CITY PLAN COMMISSION

Date and Time:	August 7, 2023 6:00 PM	Location:	Community Room 933 Michigan Avenue, Stevens Point, WI
			<u>OR</u>
			<u>Zoom Teleconferencing</u>
			Meeting ID: 822 9670 3477
			Passcode: 831987
			<u>By Computer:</u>
			https://us02web.zoom.us/j/82296703477?pwd=SHZPZjlwUHdGd1ViWktLNUpm
			<u>By Phone:</u> +1-312-626-6799 (US Chicago)

Applicant(s): - Priority Engineering LLC, representing CORTA Stevens Point 2 LLC Staff: - Adam Kuhn, Associate Planner akuhn@stevenspoint.com Parcel Number(s): 281240836240004 Zone(s): "B-5" Highway Commercial Master Plan: - Commercial / Office / Multi-Family Council District: - District 7 Ald. Kneebone Lot Information: - Frontage: 317.58 ft. - Depth: 206.38 ft. - Lot Size: 55,218 sq. ft. (1.268 ac.) Current Use: - Undeveloped Applicable Regulations: 23.02(2)(e)(3)(e) 23.02(2)(e)(5)	Request - Public Hearing and action on a request from Priority Engineering LLC, representing CORTA Stevens Point 2 LLC, for a conditional use permit to construct a car wash on an unaddressed parcel off of U.S. Highway 10 East (Parcel ID 281240836240004), consistent with Ch. 23.02(2)(e)(3)(e). - A request from Priority Engineering LLC, representing C

Submitted Architectural Plan

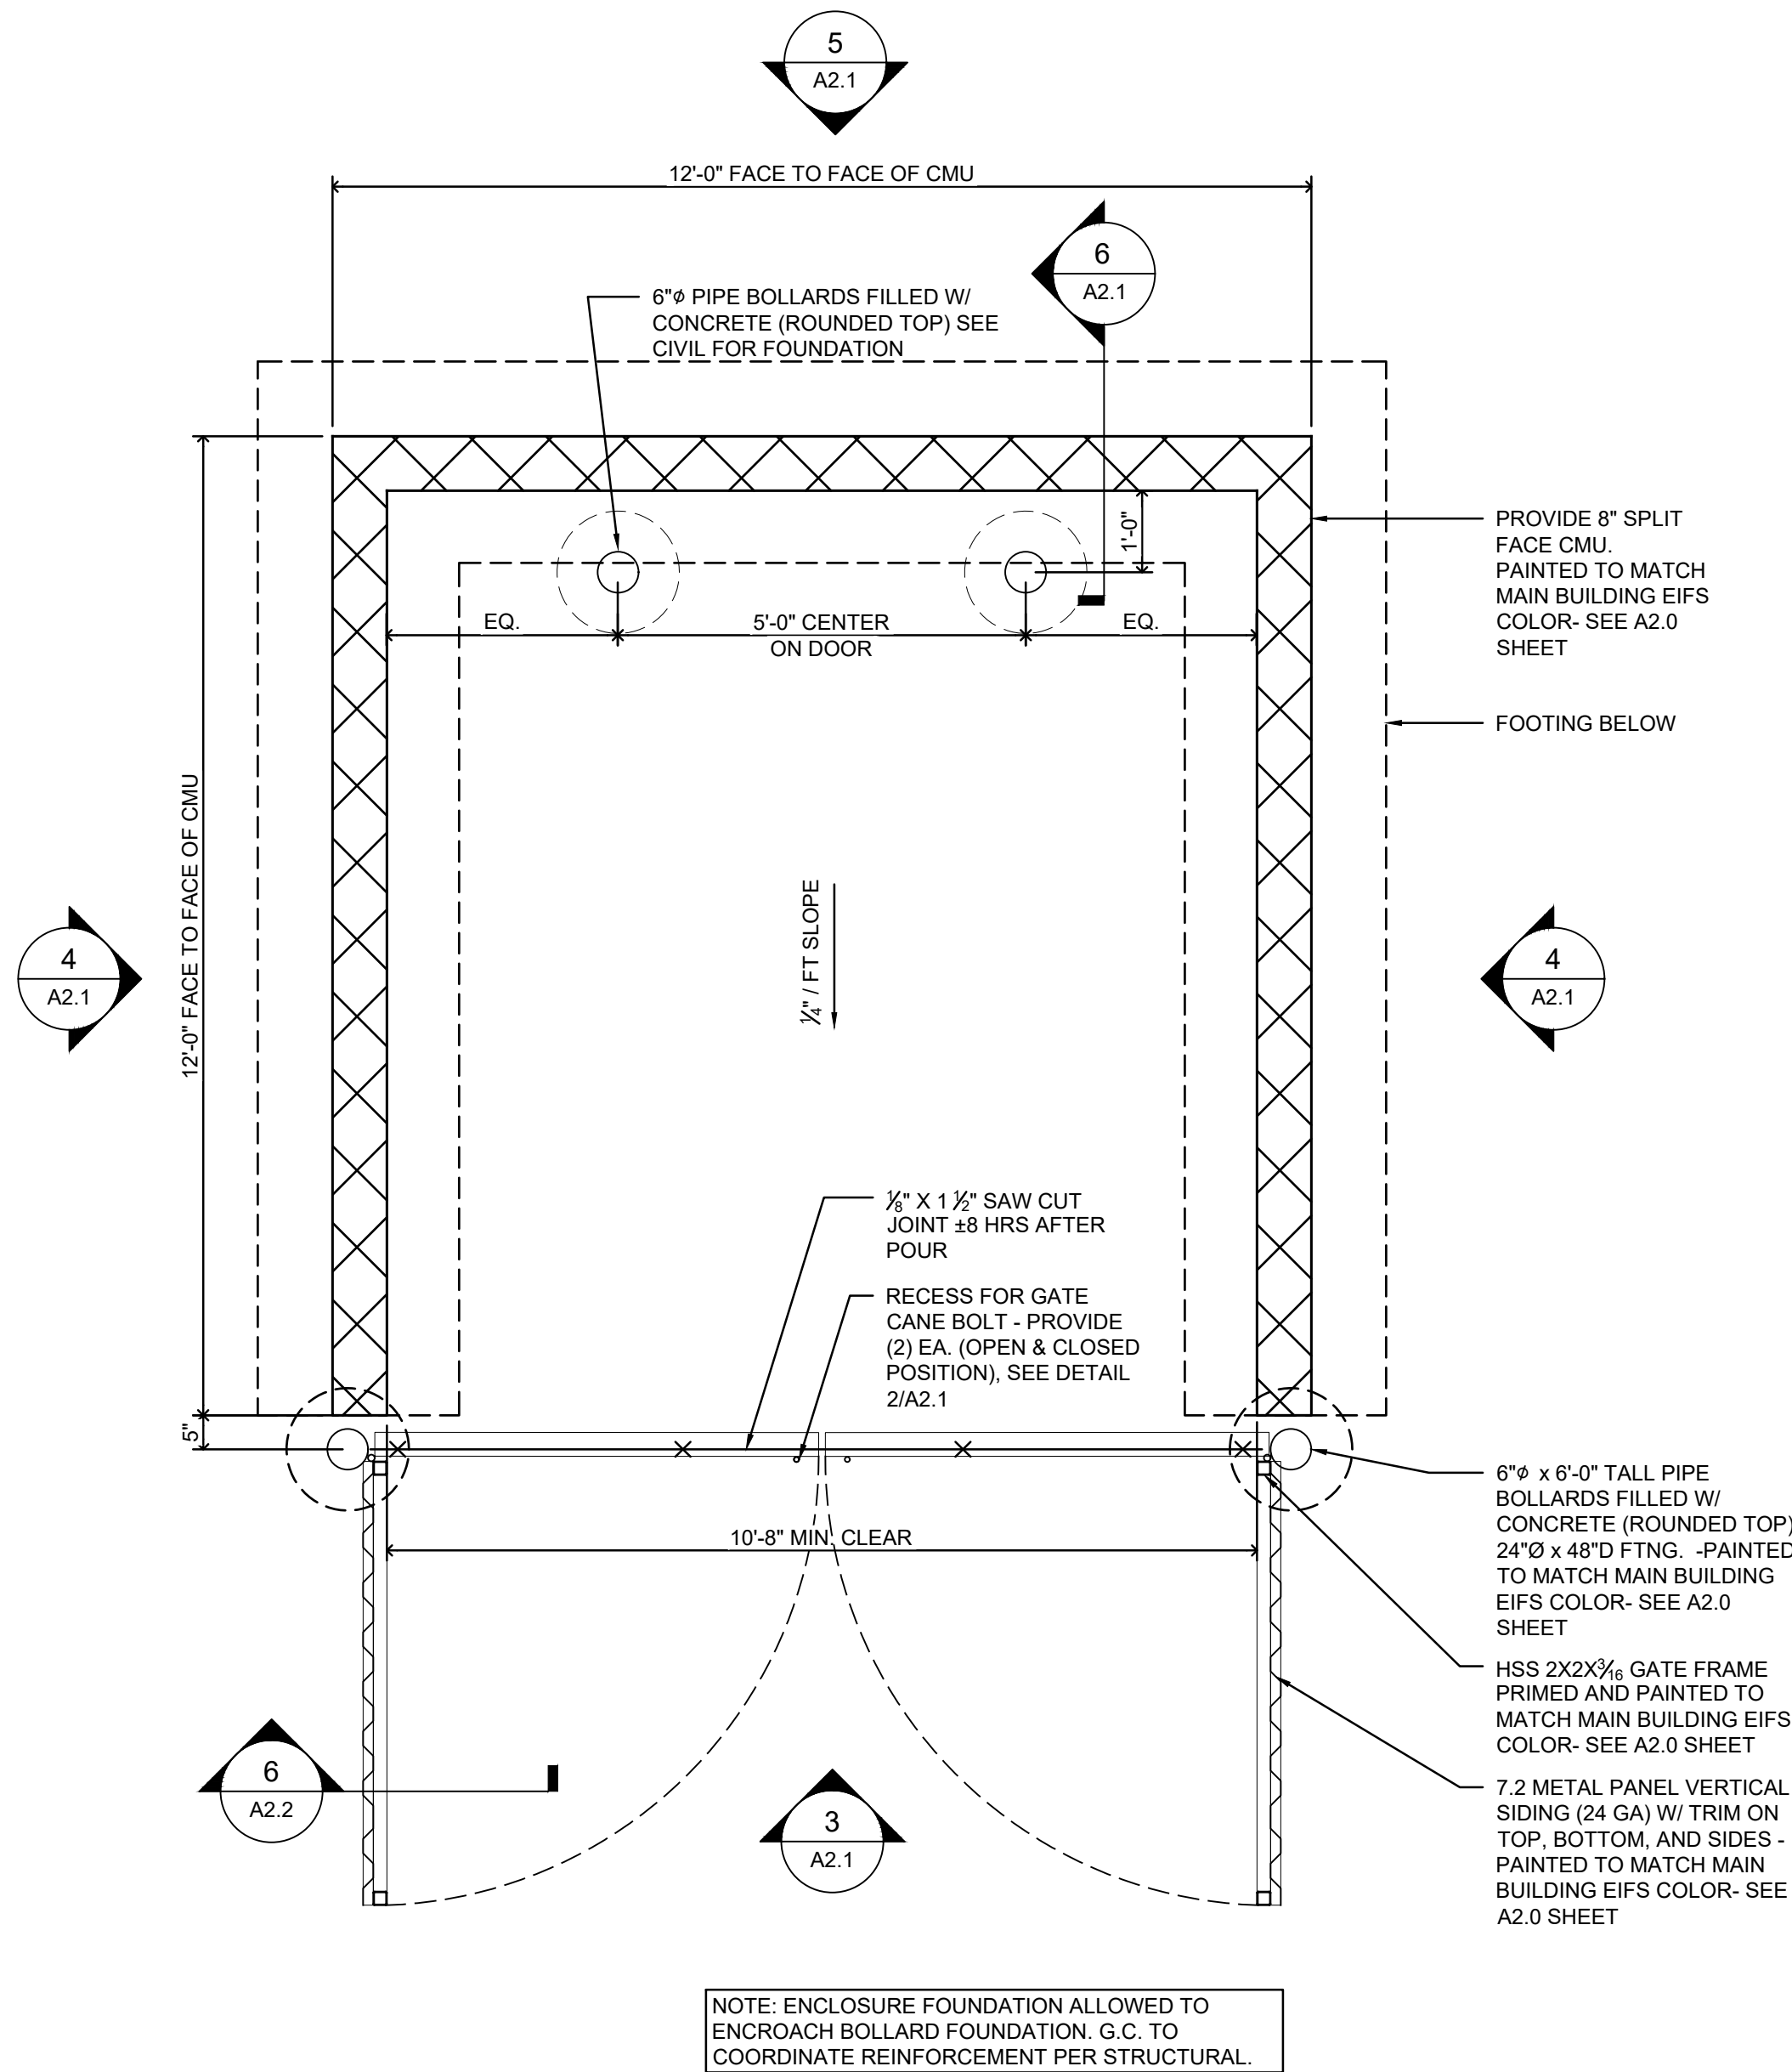
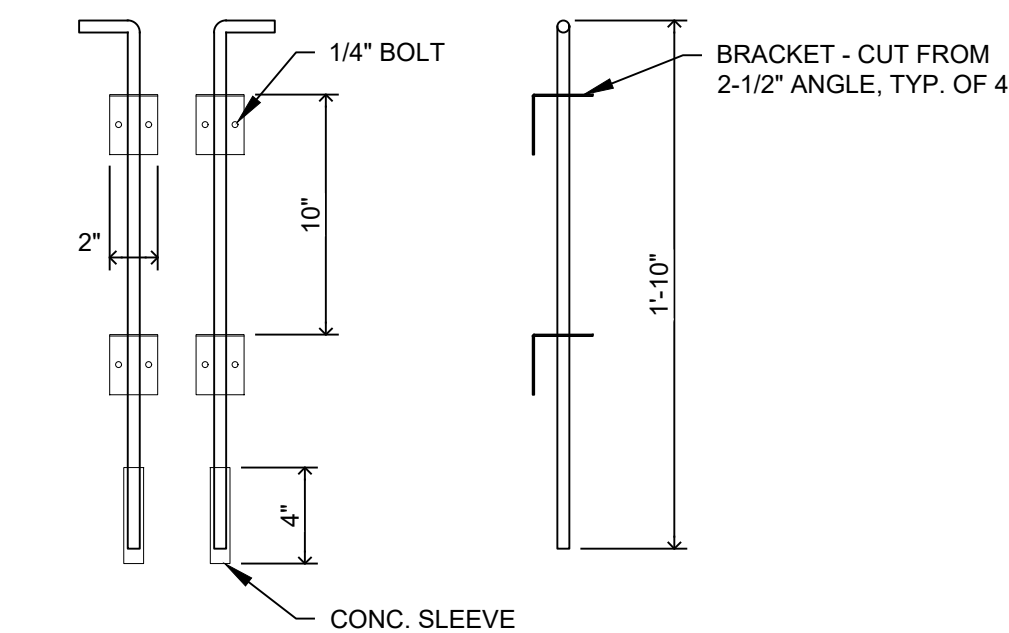
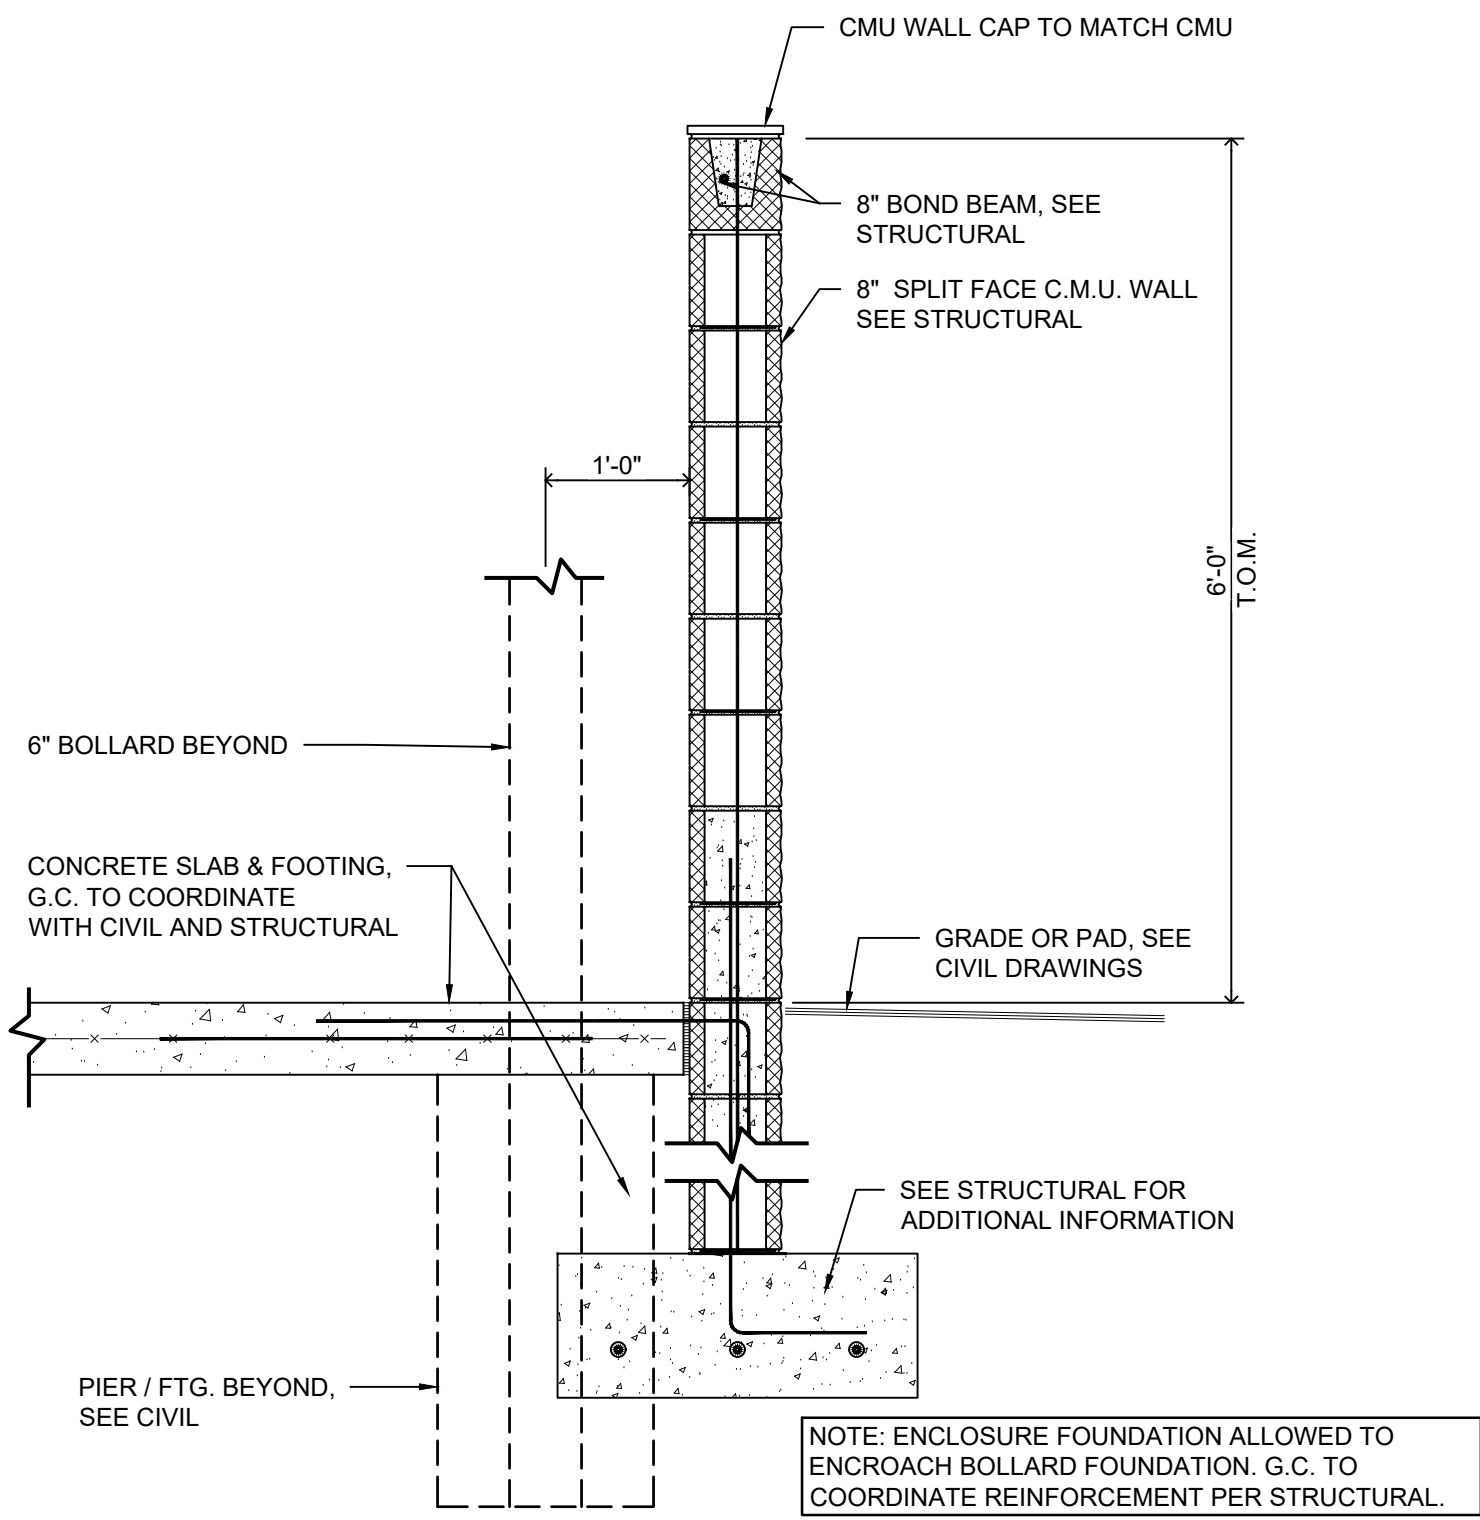
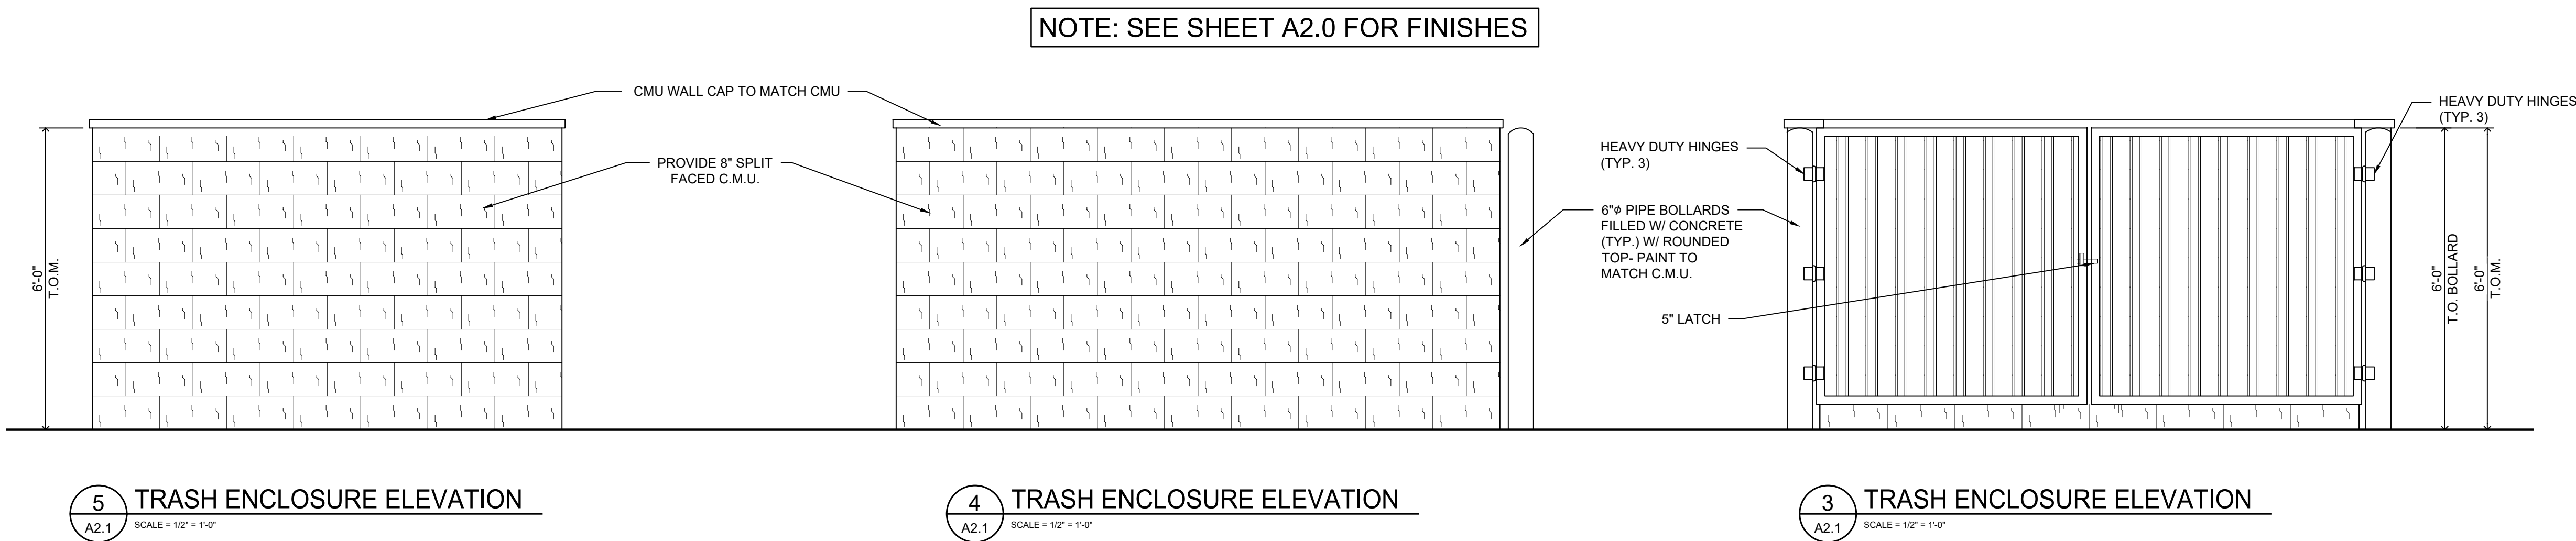
Findings: As shown within the attached elevation plan, the north facing wall of the building (parallel with U.S. Highway 10 East) consists of a blank wall with two types of façade material proposed and no other architectural

elements provided other than light fixtures. As this wall is visible from a public street, and as this structure would be one of the first views of Stevens Point for westbound traffic on U.S. Highway 10 East, modifications to the submitted elevation plan are requested to provide more architectural appeal to the building. This request, included as a condition above, seeks to provide more variation in the types of exterior building materials that is used and provide additional

architectural elements (e.g., additional windows, cornices, corbelling, quoins, etc.) to add more appeal to this north facing wall. Provided that the applicant provides updated elevation plans that are approved by City staff, staff believes that this standard is met.

7. The applicant shall provide updated architectural plans to the Zoning Administrator for review and approval. The update plan shall provide additional façade materials and architectural elements for the north-facing wall of the building.
